Access Compliance Report

Public Rights-of-Way

(Curb Ramps)

Intersection ID: 10369	Main Street: DOLPHIN_LN	Cross Street: SHANNONHOUSE_DR	Location: S
ADA ID: 01808B854180	Ramp Type: BlendTrans1	Initial Pass/Fail: Fail	Overall Compliance: No
Severity Score: 1.25			
Codes/Mitigation Info/Possible Solution		Field Measurements/Component Compliance

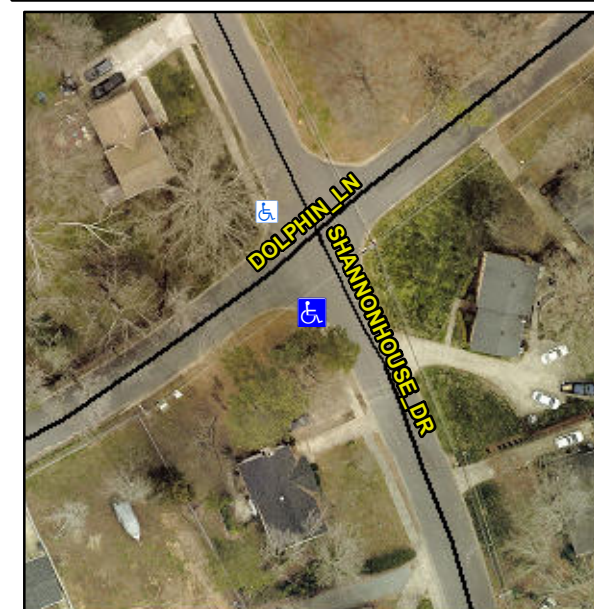
Not Found, R304.5.3

Compliance	Description	Data	Compliance	Description	Data
N/A	Ramp Length (in)	70.0	Yes	BlendTrans Slope (%)	3.9
Yes	Ramp Width (in)	60.0	No	BlendTrans XSlope (%)	2.3
N/A	Flare Type LT	N/A	N/A	Flare Type RT	N/A
N/A	Flare Slope LT (%)	N/A	N/A	Flare Slope RT (%)	N/A
N/A	Flare Traversable LT?	N/A	N/A	Flare Traversable RT?	N/A
N/A	Landing Length (in)	N/A	N/A	DWS Provided?	N/A
N/A	Landing Width (in)	N/A	N/A	DWS Contrast?	N/A
N/A	Landing Slope (%)	N/A	N/A	DWS Length (in)	N/A
N/A	Landing X Slope (%)	N/A	N/A	DWS Full Width?	N/A
N/A	Landing Curb? (Y/N)	N/A	N/A	DWS Offset (in)	N/A
N/A	Shared Landing?	N/A			
N/A	Gutter Ponding?	N/A	N/A	Gutter Slope (%)	N/A
N/A	Gutter Lip Ht (in)	N/A	N/A	Gutter X Slope (%)	N/A
N/A	Painted X Walk1?	No	N/A	Painted X Walk2?	N/A
	X Walk 1 Direction	To NW		X Walk 2 Direction	N/A
	X Walk 1 Width (in)	N/A		X Walk 2 Width (in)	N/A
	X Walk 1 Slope (%)	1.5		X Walk 2 Slope (%)	N/A
	X Walk 1 X Slope (%)	1.0		X Walk 2 X Slope (%)	N/A

N/A	Ramp inside XWalk1?	N/A	N/A	Ramp inside XWalk2?	N/A
	Road Slope (%)	1.0		Clear Space?	N/A
	Road X Slope (%)	1.5	N/A	Clear Space to XWalk (in)	N/A
N/A	Any Obstructions?	N/A	N/A	Storm Grate/Utility Hazard?	N/A
	Obstruction Type			Storm Grate/Utility Type	
		N/A			N/A
			Yes	Surface Condition? (G/P)	Good
			No	Curb Slope (%)	24.8

Remove & Replace Curb Ramp With Two New Directional Ramps or Equivalent.
